Planning Commission Meeting

Meeting Date: Tuesday, March 19, 2019

5.3. 18-047 DR/VAR/ADJ Sandy Vault Self Storage 41 - 243

SANDY VAULT A SELF STORAGE FACILITY DESIGN REVIEW CHAMPION WAY, SANDY, OREGON 97055

A1.3

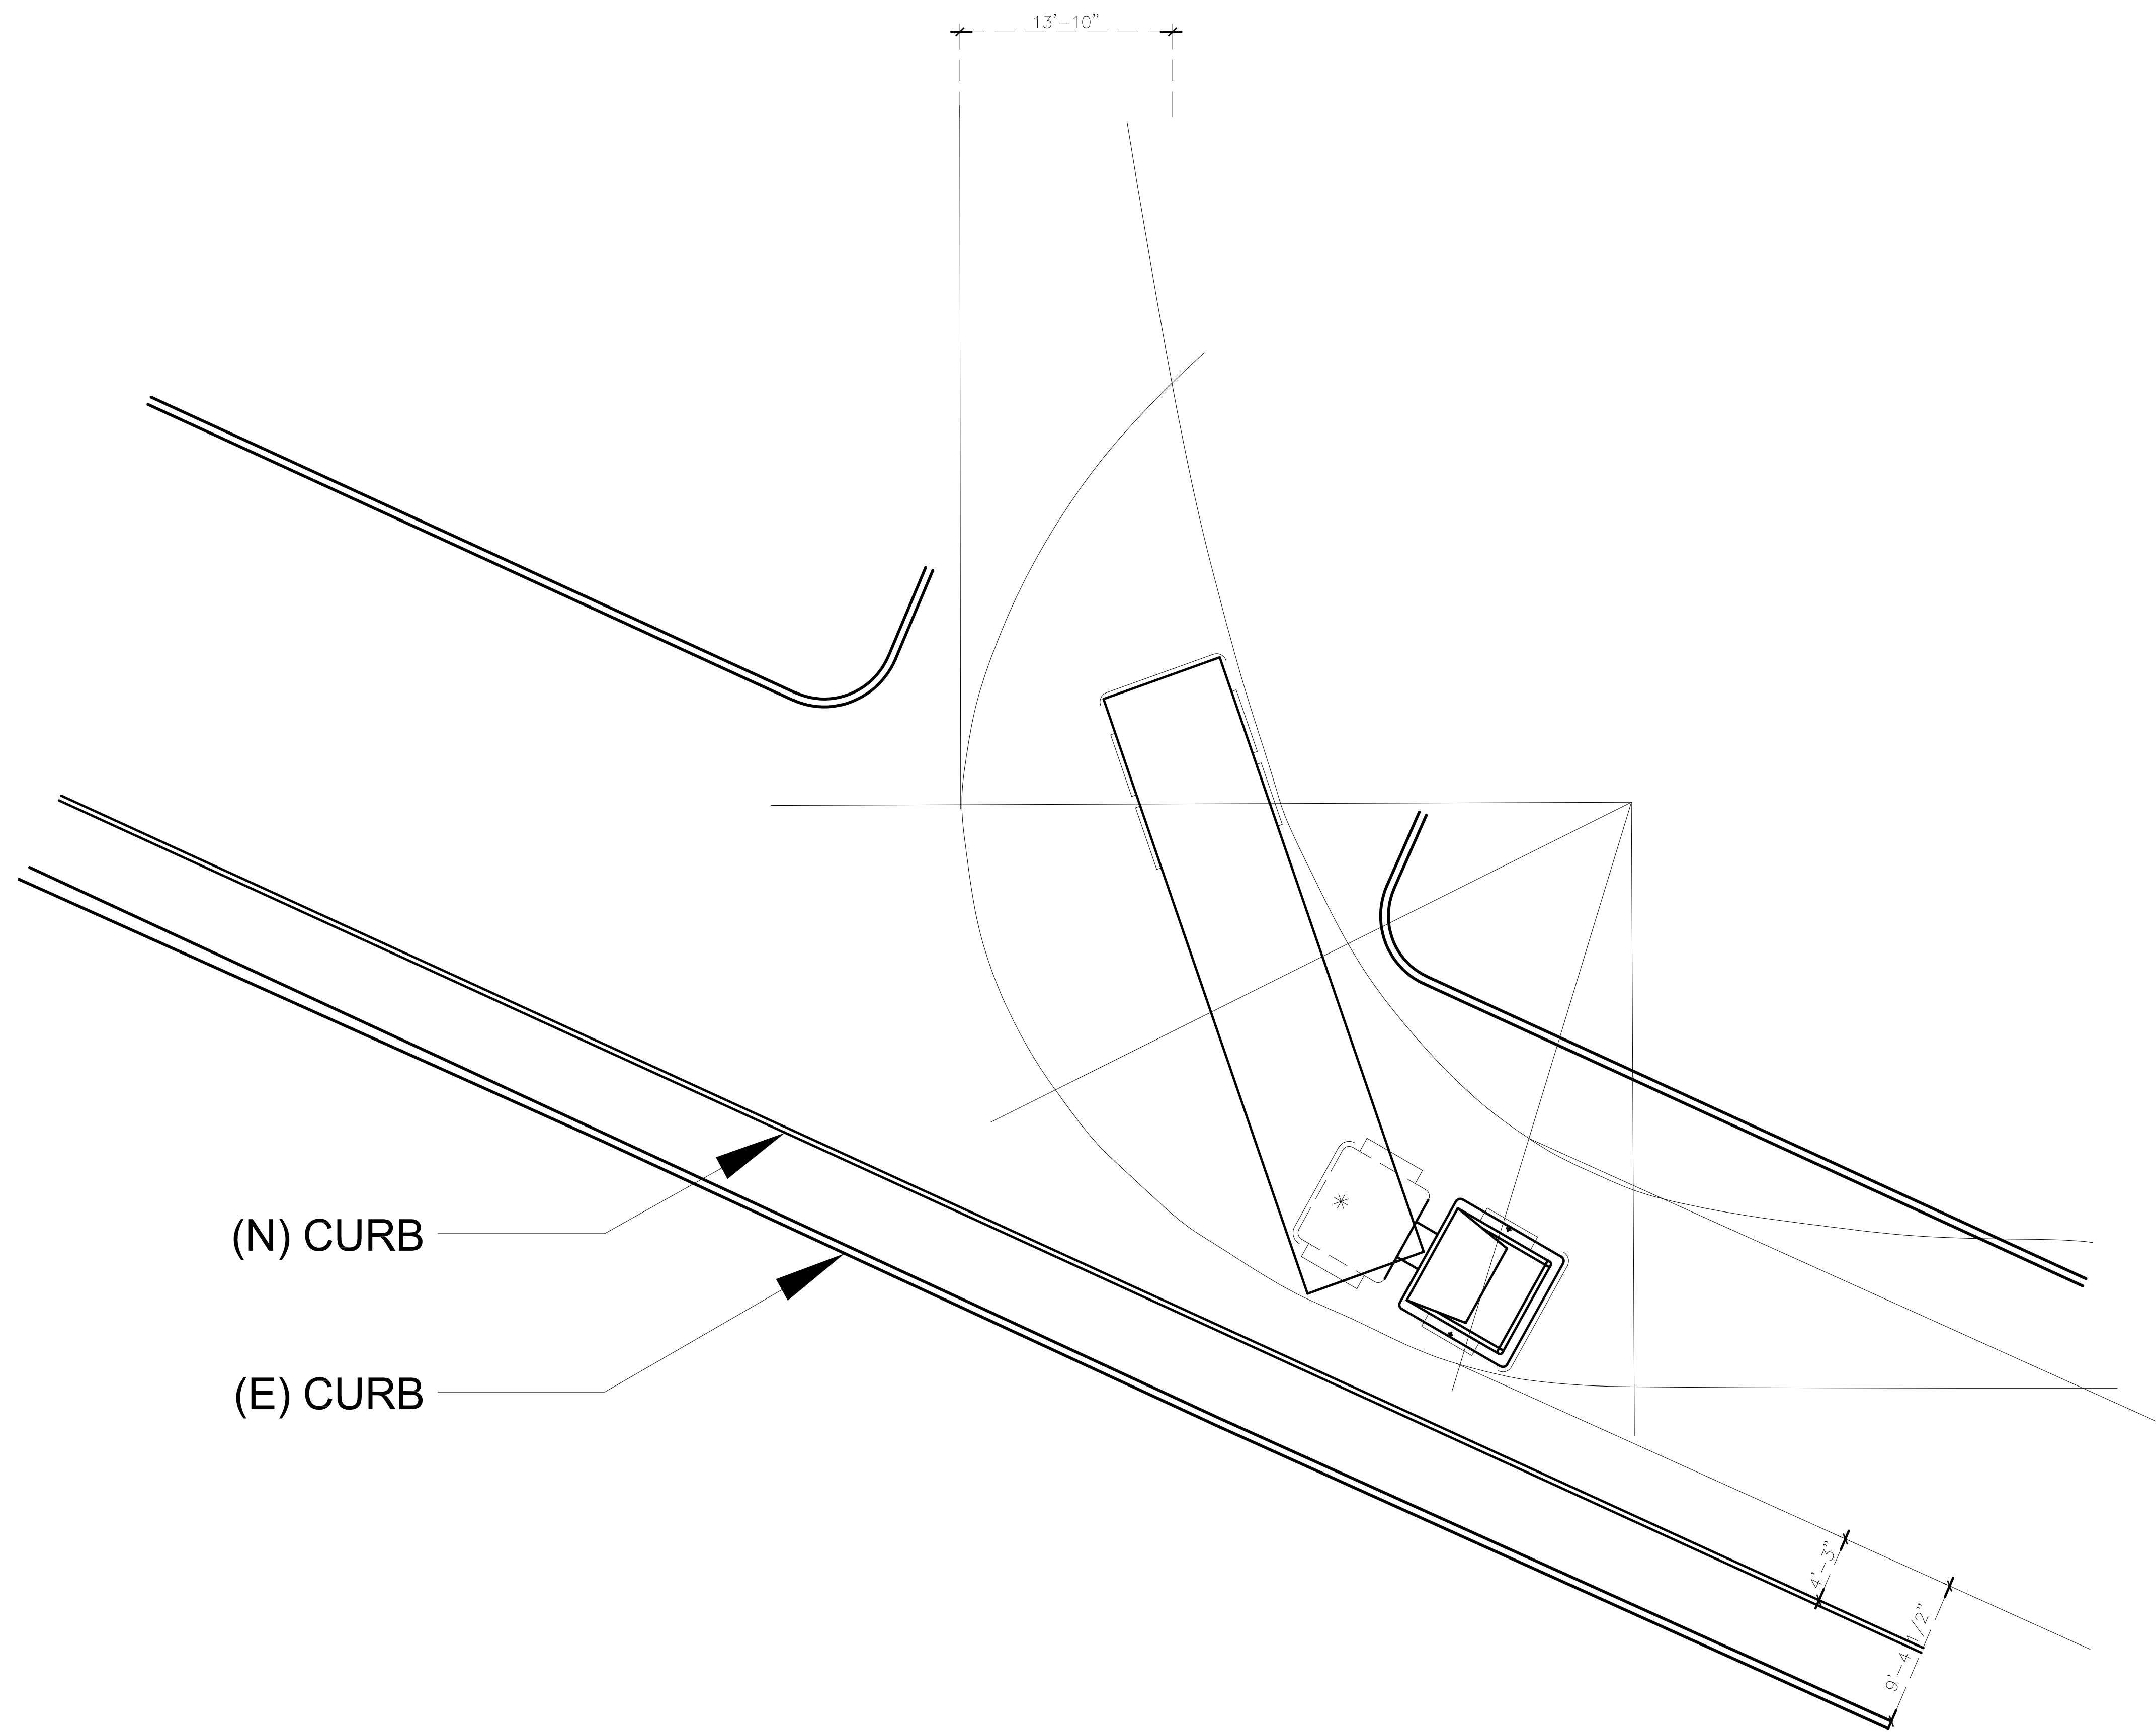
- It is not clear what the truck turning diagram on sheet A1.3 is for. There are no dimensions on the size of the access the truck is turning from or the width of the roadway the truck is turning onto much less which drive or roadway is which. There is no information on the type or size of vehicle (WB-40, WB-50, WB-62, etc.). A radius is shown but there are no dimensions. The distance between the center point of the radius and the front axle is not shown. The wheel path (inside and outside), swept path and overhang are not identified. It is not clear what the (N) and the (E) refer to in relation to the curb.

SHEET TITLE
ELEVATIONS
BUILDING 1 & 2

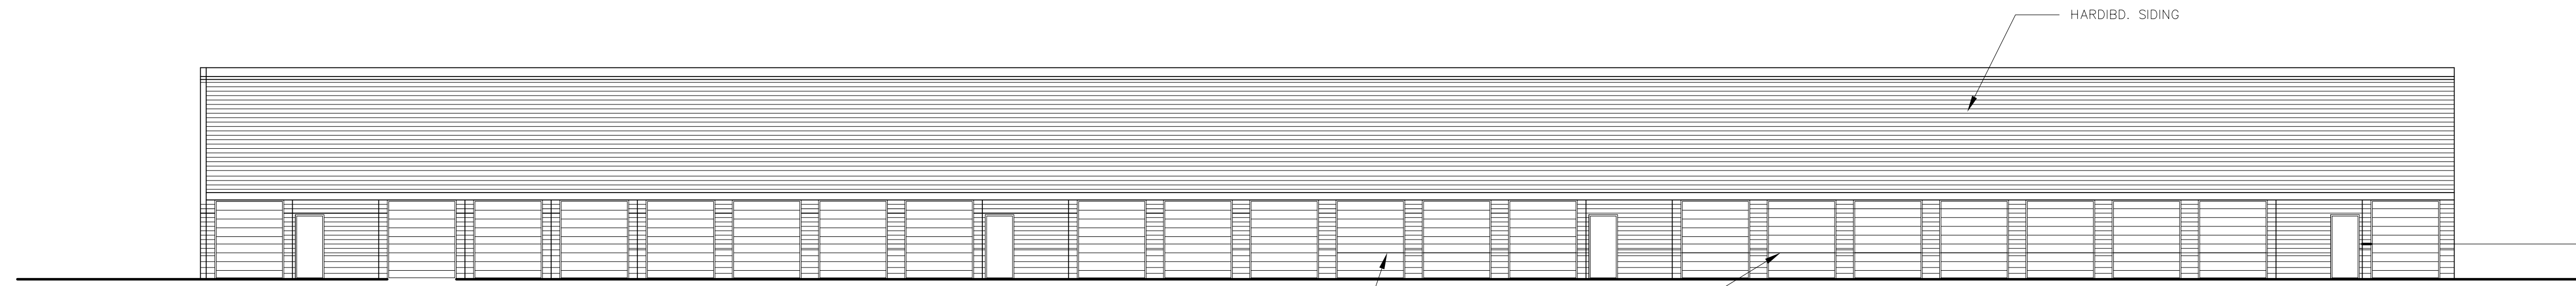
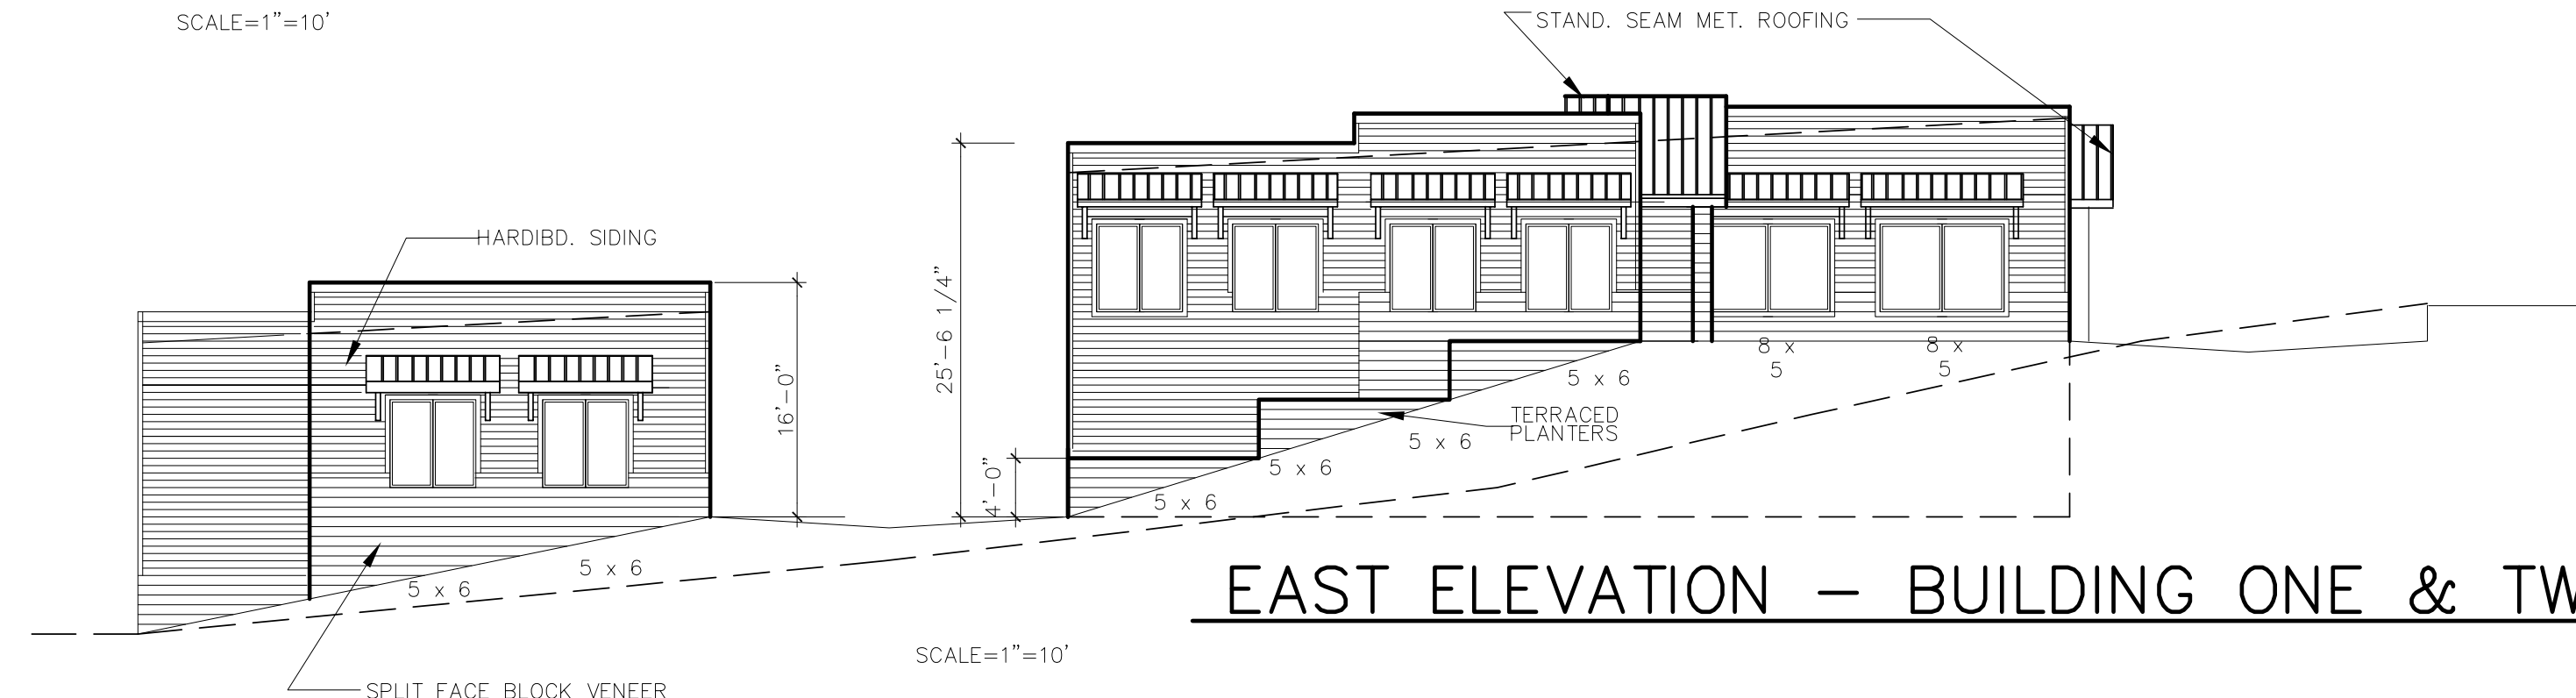
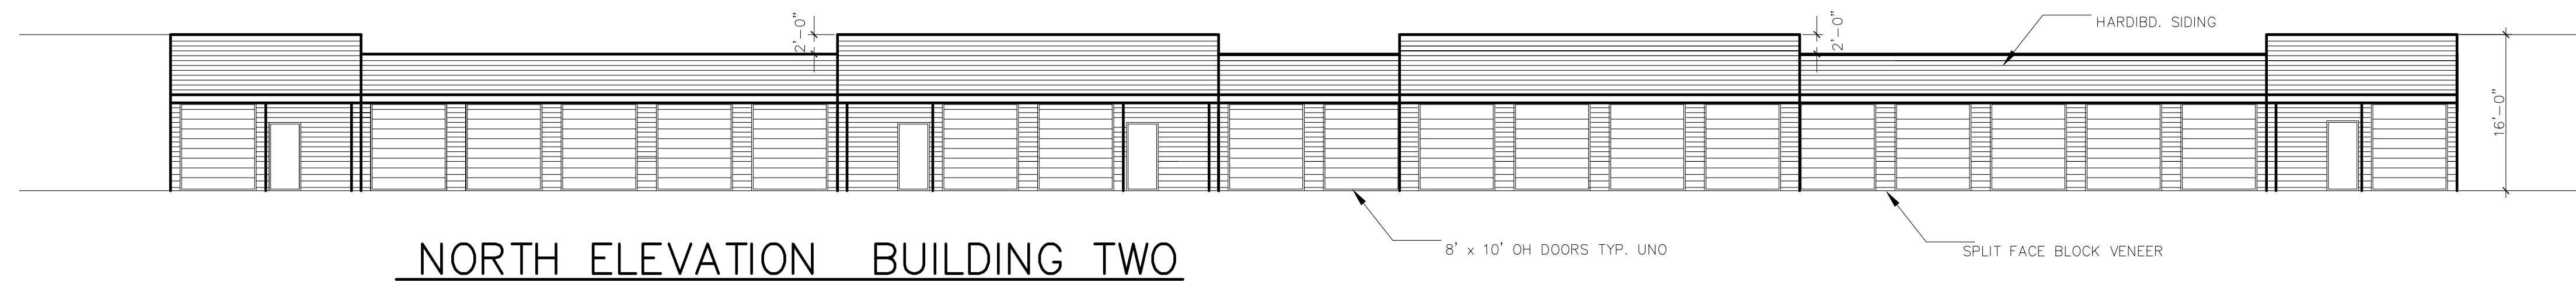
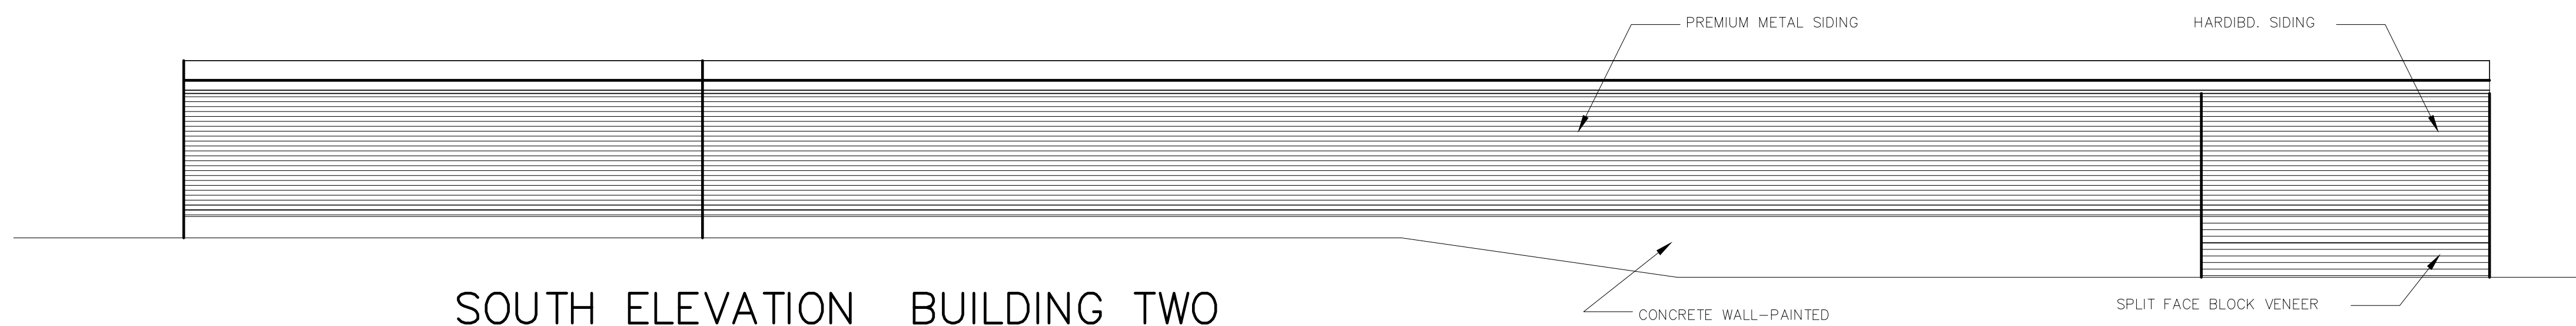
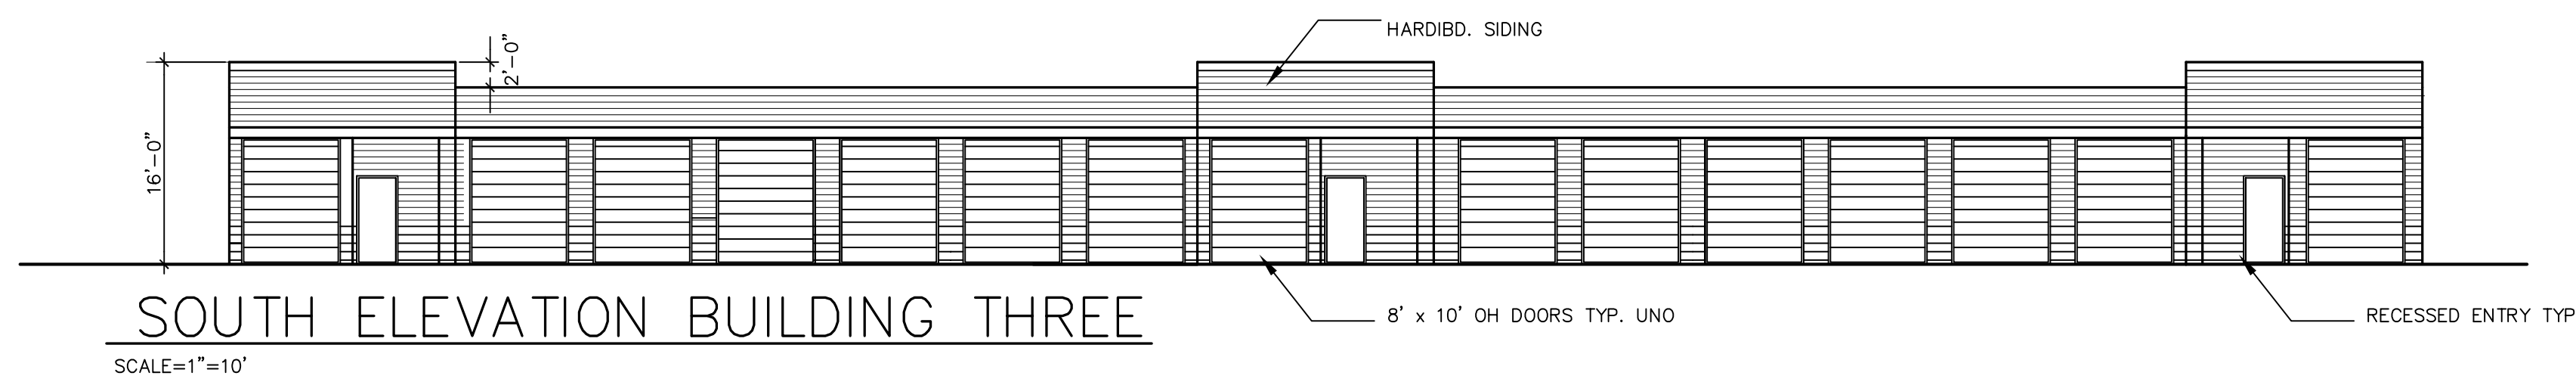
RESPONSE: The primary entrance for the proposed self-storage facility is located on the north elevation of Building 1 and has a covered recessed entry way with heavy timber trusses. The submitted elevations (Exhibit C, Sheet A3) detail additional 5 foot deep pedestrian shelters with heavy timber trusses over the remaining three doors on the north elevation of Building 1. The elevations do not show gabled entries over the pedestrian entryways on the lower level (south elevation) of Building 1 or on Buildings 2-5; however, the submitted narrative (Exhibit B) states that all buildings will have entrances that are recessed 5 feet and covered.

RESPONSE: *The applicant is proposing to use metal siding on Buildings 2, 3, 4, and 5 and is requesting a variance to use 36 percent metal siding (20 percent more than the 30 percent maximum allowed); however, the submitted elevations (Exhibit C, Sheet A4) detail 100 percent metal siding on some facades. The applicant's deviation, adjustment, and variance narrative (Exhibit B) states that the metal siding is visually indistinguishable from the hardie board lap siding and that it will only be used on facades that will be hidden from view by retaining walls, trees and/or other buildings. The variance request will be discussed further in Chapter 17.66 of this document.*
